29 October 2017
Our Ref: 15168

34 Yarrunga Street, Prestons

I have considered the “traffic” issues raised by the Department of Planning (letter of 30.8.17), RMS (letters of 30.8.17 and 13.10.17) and Council (letter of 24.8.17 and attached memos) and respond in the following:

**SWEPT PATH ANALYSIS
OF A 25m ARTICULATED
VEHICLE TURNING RIGHT FROM
BERNERA INTO YARRUNGA
AND A 19m ARTICULATED
TURNING LEFT FROM
YARRUNGA INTO BERNERA**

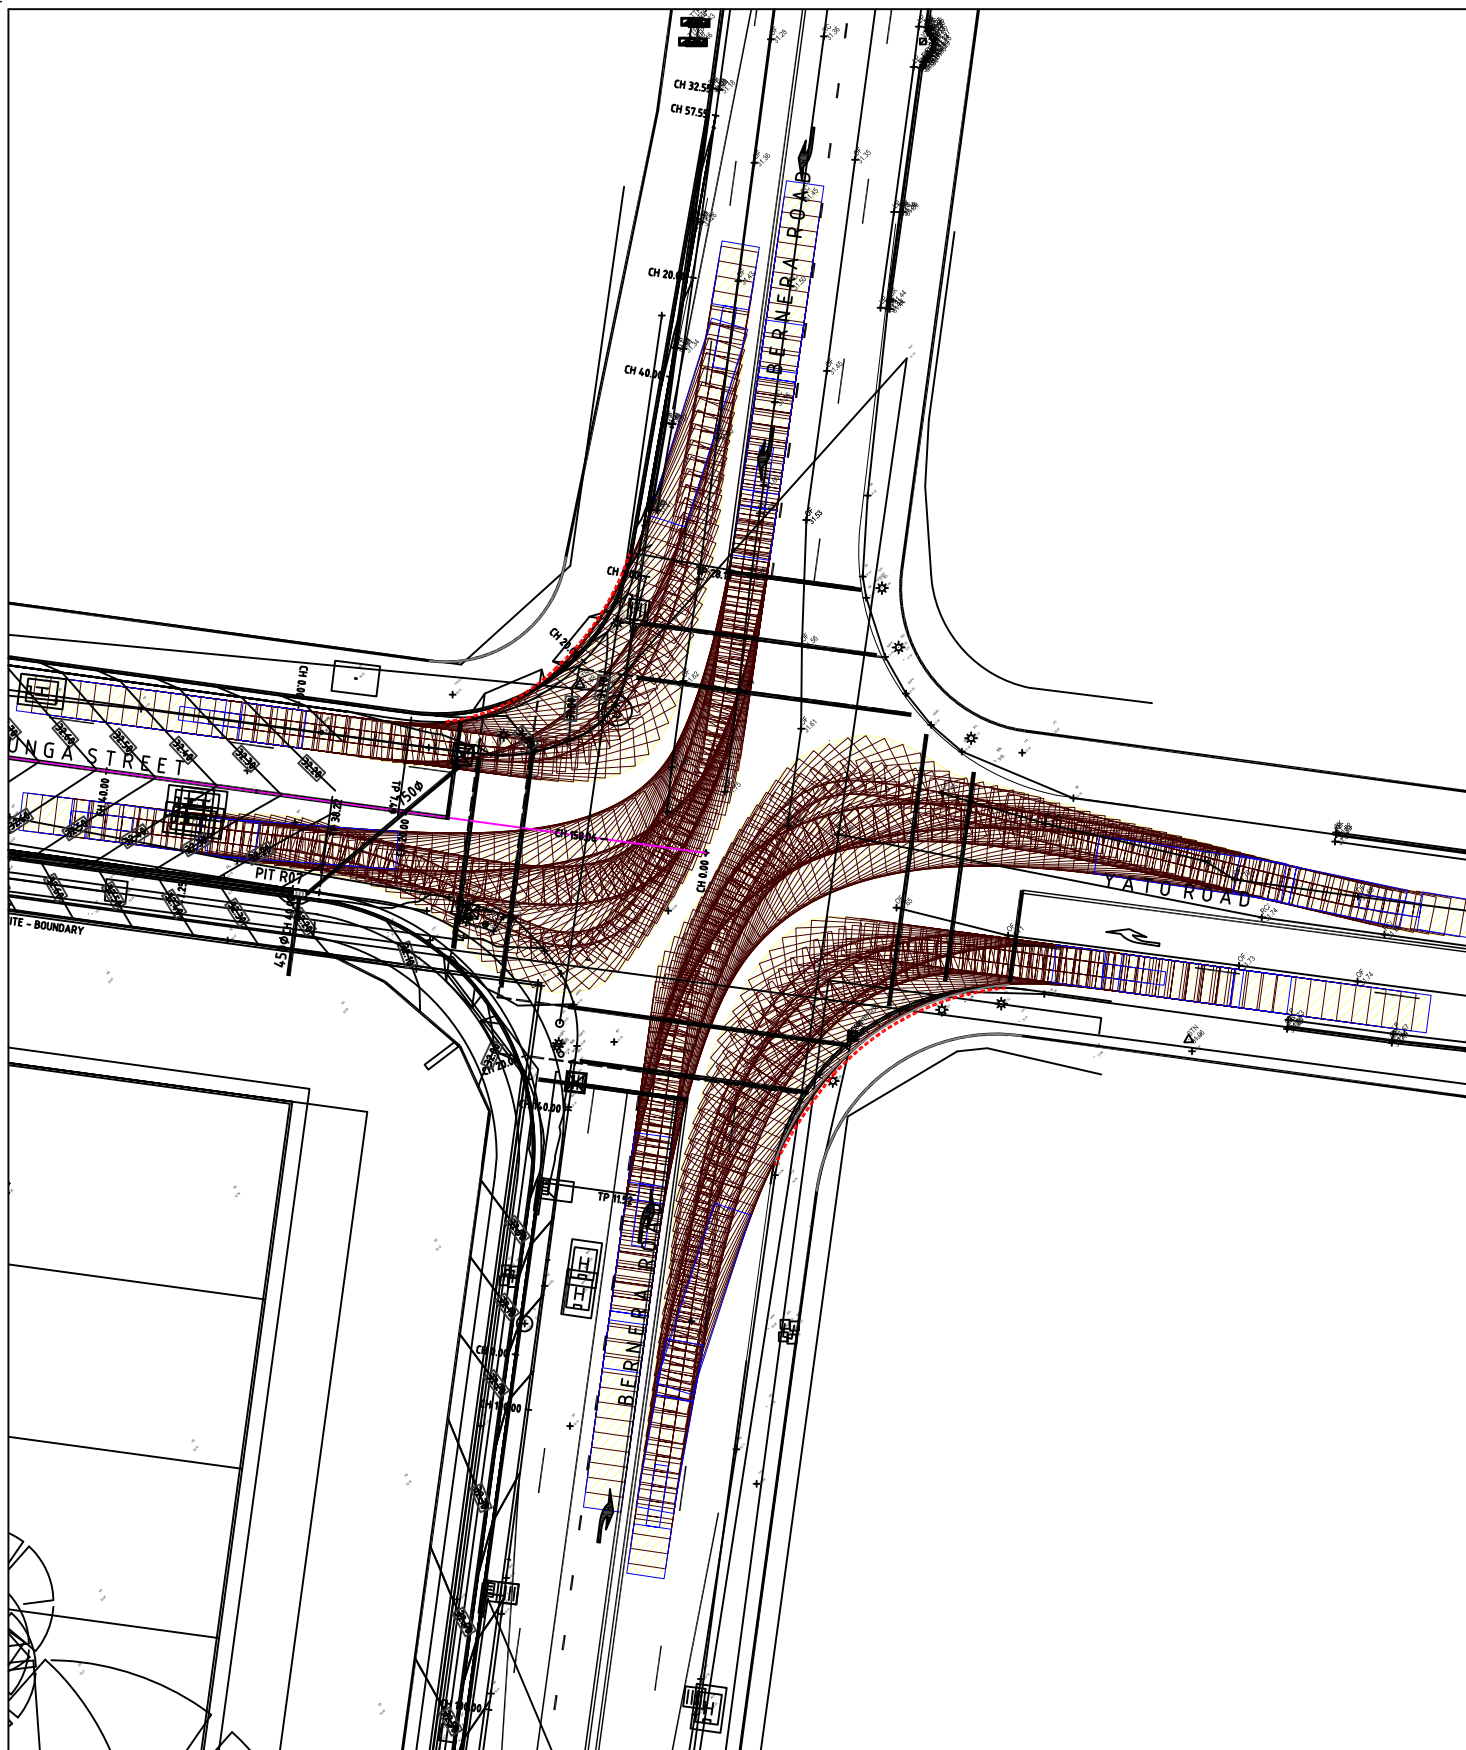
SP 1 – B Double trucks turning right and semi-trailers turning left with some minor trim to the proposed kerbs on the NW and SE corners. It would be proposed that regulatory signage be installed “NO LEFT TURN ON GREEN ARROW VEHICLES OVER 19M LONG” for the left turn movements (this is equivalent to the relatively common “NO RIGHT/LEFT TURN VEHICLES LESS THAN X M EXCEPTED”).

SP 1

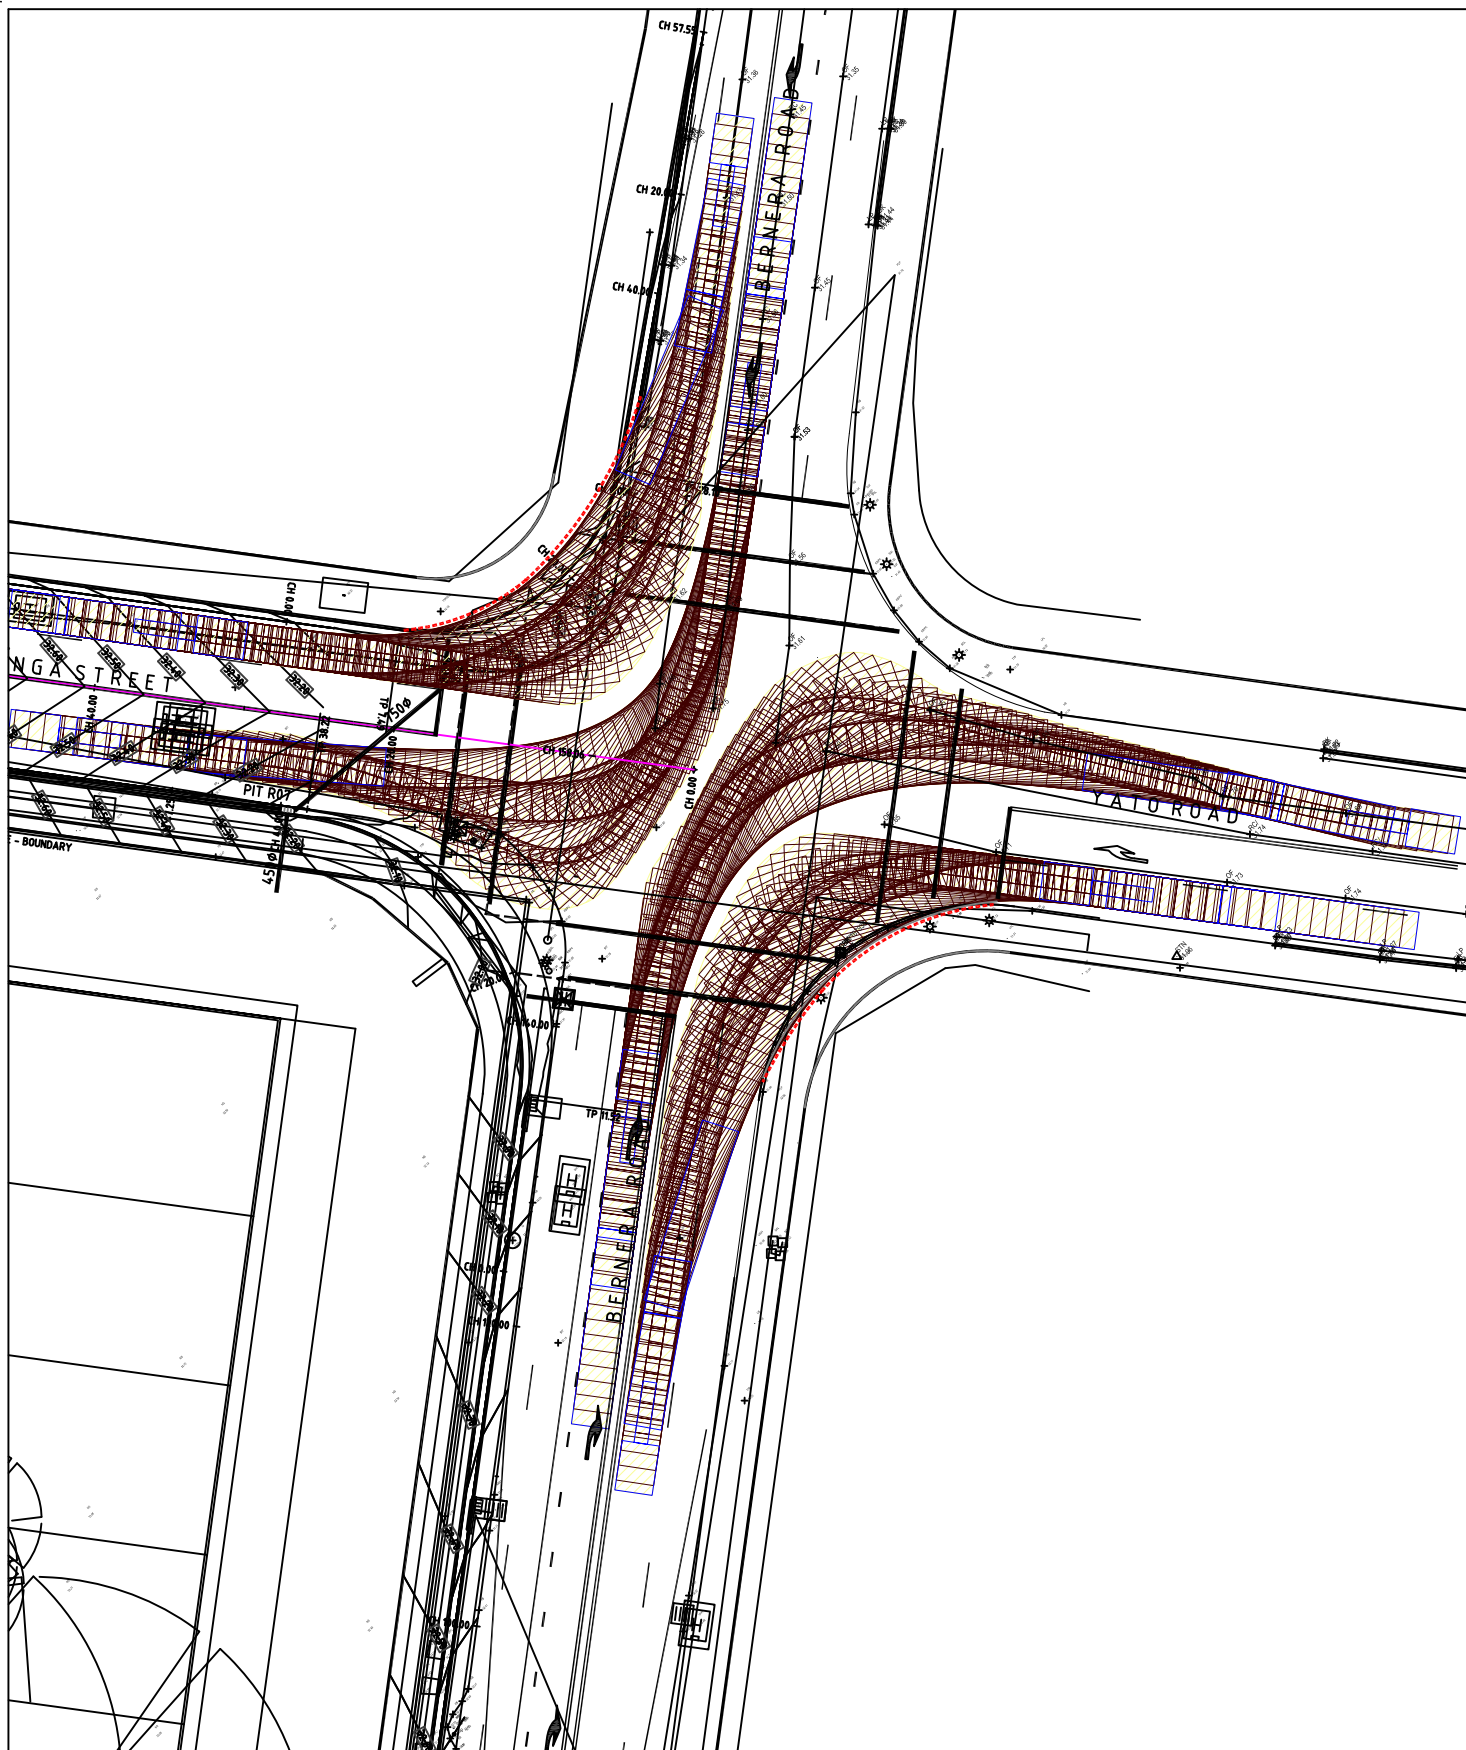
Further turning path assessment has been undertaken as Council has advised that it is not possible to acquire the necessary land on the NW and SE corners in the short term to achieve the final intersection arrangement for the left turn movements although there is a current DA submitted for the site on the NW corner of the intersection and Council will impose a Consent Condition on that DA requiring dedication of the required land necessary to achieve the required intersection geometry. The attached SP 1, 2 and signage/roadmarking diagrams indicate:

SP 2

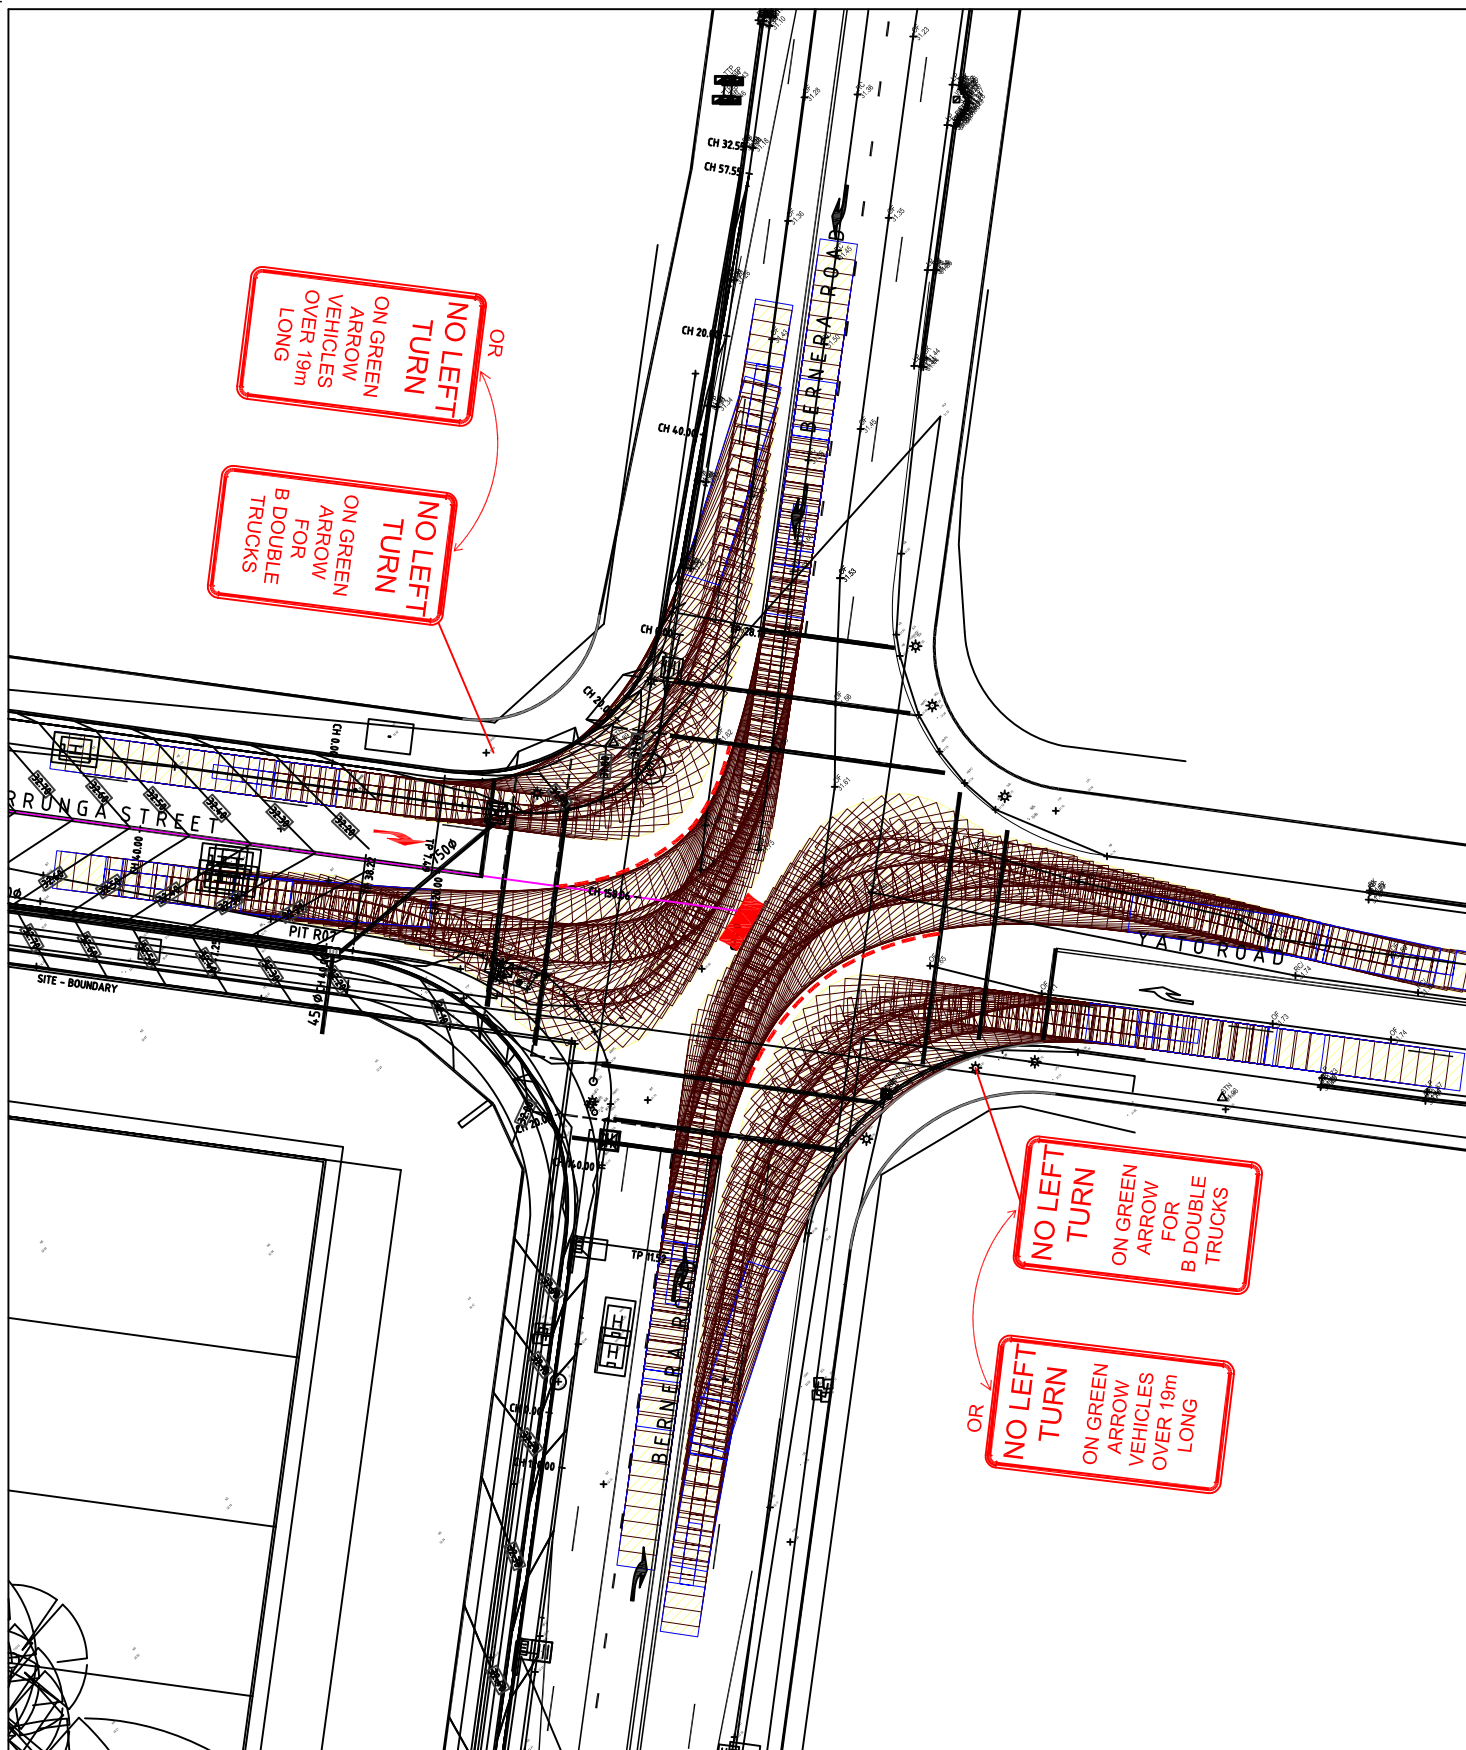
SP 2 – B Double trucks turning right and left requiring some greater trim of the proposed kerbs with implications for the location of kerb ramps and cyclist/pedestrian movements.
